MONTICELLO NUCLEAR GENERATING PLANT
Docket No. 50-263 License No. DPR-22

Response to August 21, 1975
ATWS Letter

This enclosure transmits corrections to the report submitted by L. O. Mayer (NSP) to A. Giambusso (USNRC) on April 1, 1975 entitled "Anticipated Transients Without Scram: Study for the Monticello Generating Plant, NEDO-20846, March 1975." The changes include the following:

**STUDY FOR THE
MONTICELLO
NUCLEAR GENERATING PLANT**

Figure 4-3. Monticello MSIV Closure Transient -- ATWS Response with ATWS Modifications

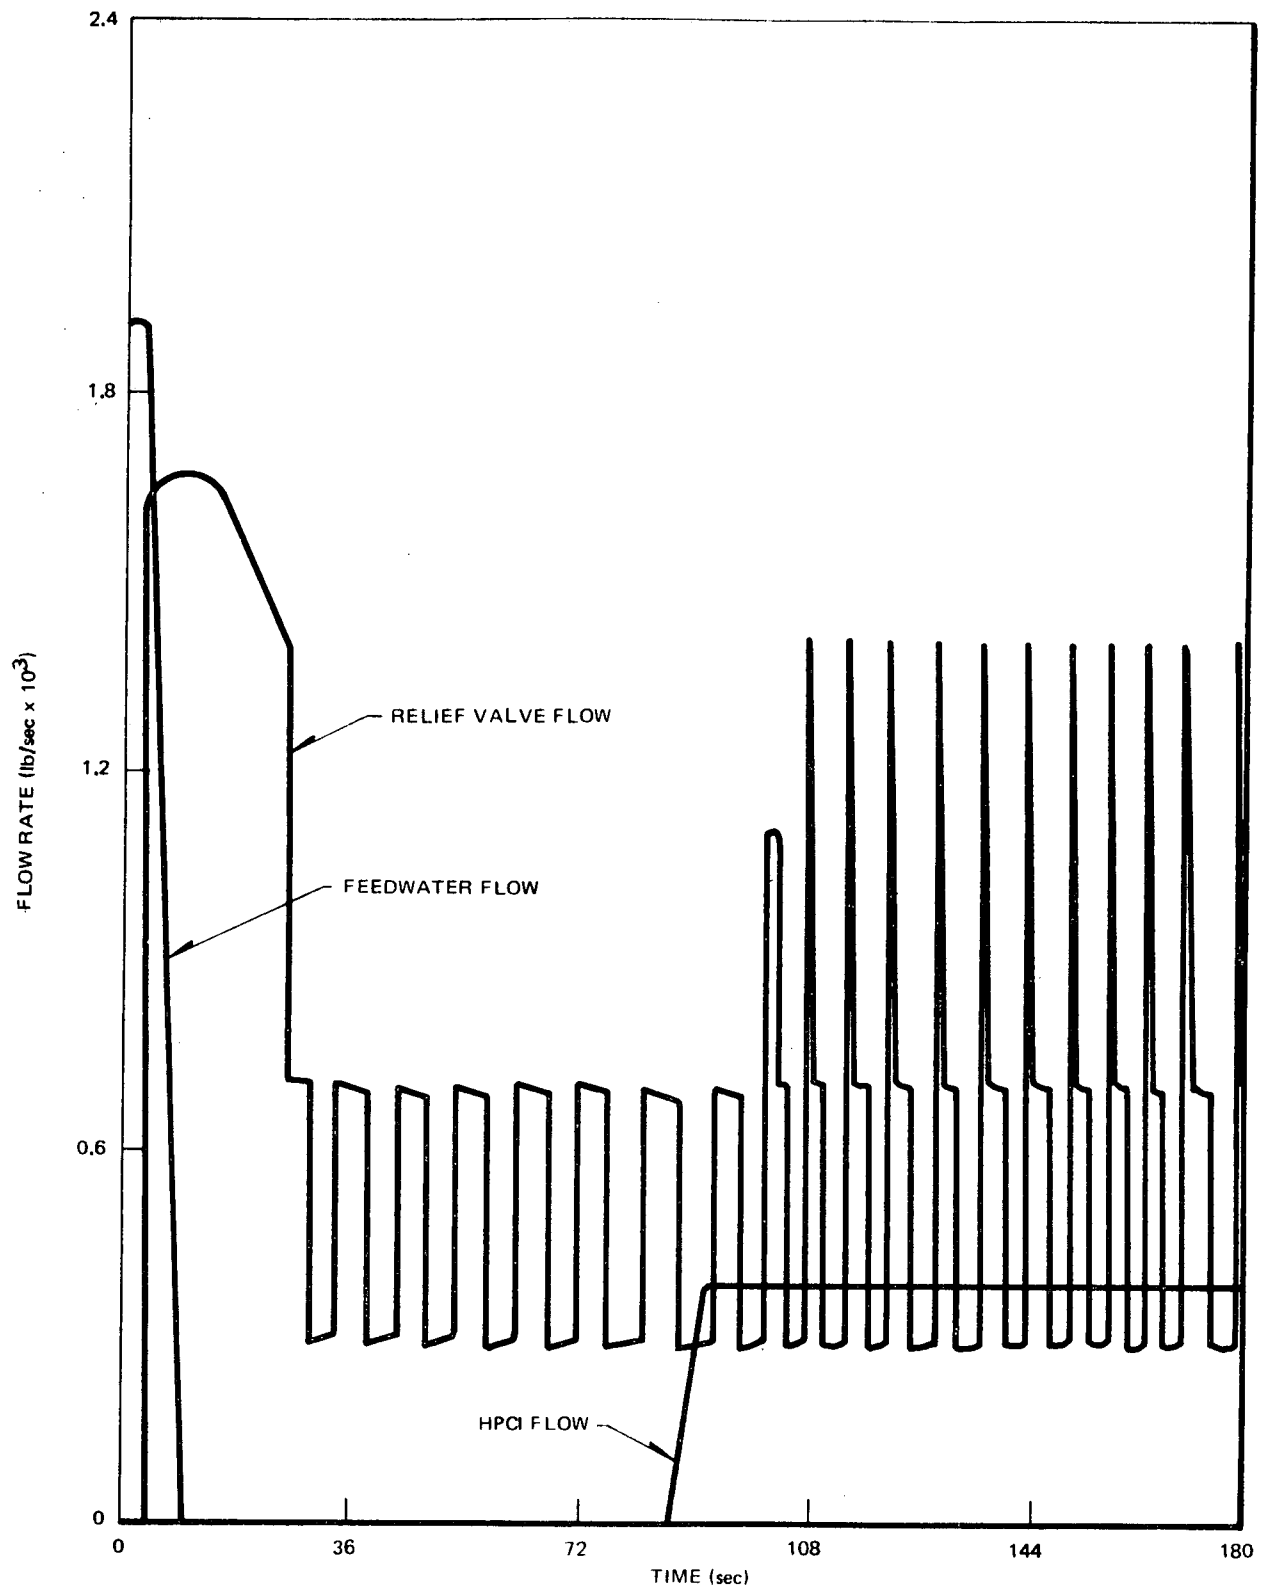
In figure 4-3 the relief valve flow oscillates between about 3,000 and 7,000 lb/sec from about 30 seconds to 95 seconds after the ATWS. At about 108 seconds the relief valve flow begins to oscillate between 3,000 and 14,000 lb/sec. Explain this difference in the peak relief valve flow.

Please note that the ordinate of Figure 4-3 has been corrected to read "Flow Rate (lb/sec x 10^3)" rather than "Flow Rate (lb/sec x 10^4)."

Figure 4-3 shows the ATWS analysis assuming three plant modifications initiated upon high reactor pressure, recirculation pump trip, feedwater pump trip and ADS inhibit.

Upon MSIV closure, reactor pressure rises causing the recirculation and feedwater pumps to trip at 4 seconds. The former causes reduction in the flow through the core. Stoppage of feedwater causes the reactor water level to gradually drop (thereby further decreasing the core flow) and also reduces the sub-cooling of the core inlet flow. Both core flow decrease and core inlet sub-cooling decrease result in increased core average voids and therefore decreased core power. Therefore, after the initial pressure and power spikes subside (i.e., after about 30 seconds) the reactor power attains a level of approximately 30% of the initial value. With MSIV's closed, this power is relieved from the reactor pressure vessel by steam flow through the relief valves which are assumed to operate in four groups. At this power level only two relief valve groups are sufficient to relieve all the energy generation. The opening and closing characteristics of the relief valves cause the relief flow to oscillate between approximately 350 lb/sec and 700 lb/sec (which indicates that the first group of relief valves is open and the second group is cycling).

The reactor level continues to drop due to continued power generation and lack of feedwater flow. When it reaches the low low level, the HPCI system is initiated. The HPCI flow starts at about 85 seconds and brings water of enthalpy 90 BTU/lbm into the reactor. This relatively cold water increases the core inlet sub-cooling resulting in slightly decreased core voids and increased core power. To relieve the increased power more relief valves are called upon to act. This combined with the dynamic characteristics of the relief valves causes the relief flow to oscillate between 350 lb/sec and 1,400 lb/sec after about 100 seconds (indicating that the first group of valves is open and the next three groups are cycling).

Figure 4-4. Monticello MSIV Closure Transient – ATWS Containment Response with ATWS Modifications

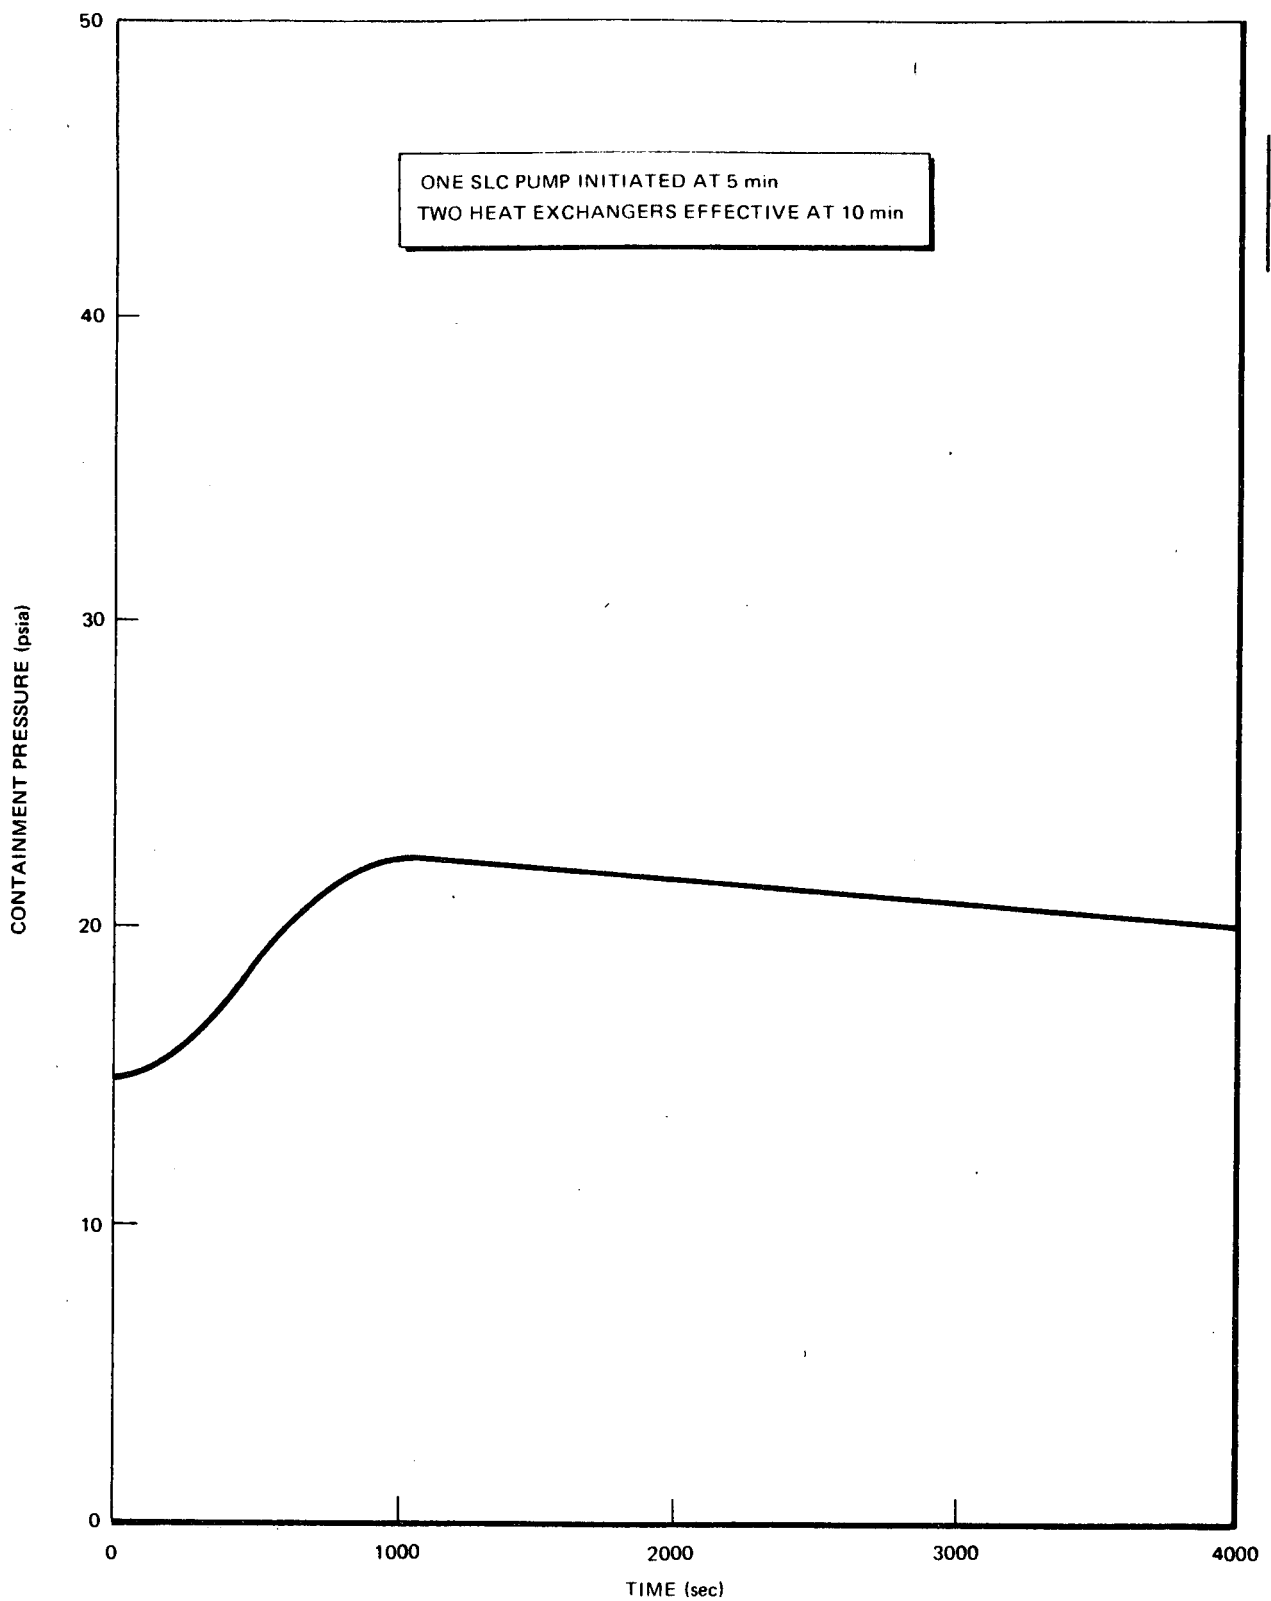
Provide the peak torus water temperature reached during the MSIV closure ATWS. Provide and justify a torus water temperature limit. If the calculated temperature exceeds the limit, discuss the plant modifications needed to keep torus water temperature below the proposed limit. If the peak torus water temperature exceeds 170°F discuss plant modifications needed to keep this temperature below 170°F.

Containment pressure will also increase along with pool temperature. The containment pressure transient is shown in Figure 4-4. The maximum containment pressure is 7.3 psig, which is within the guide values.
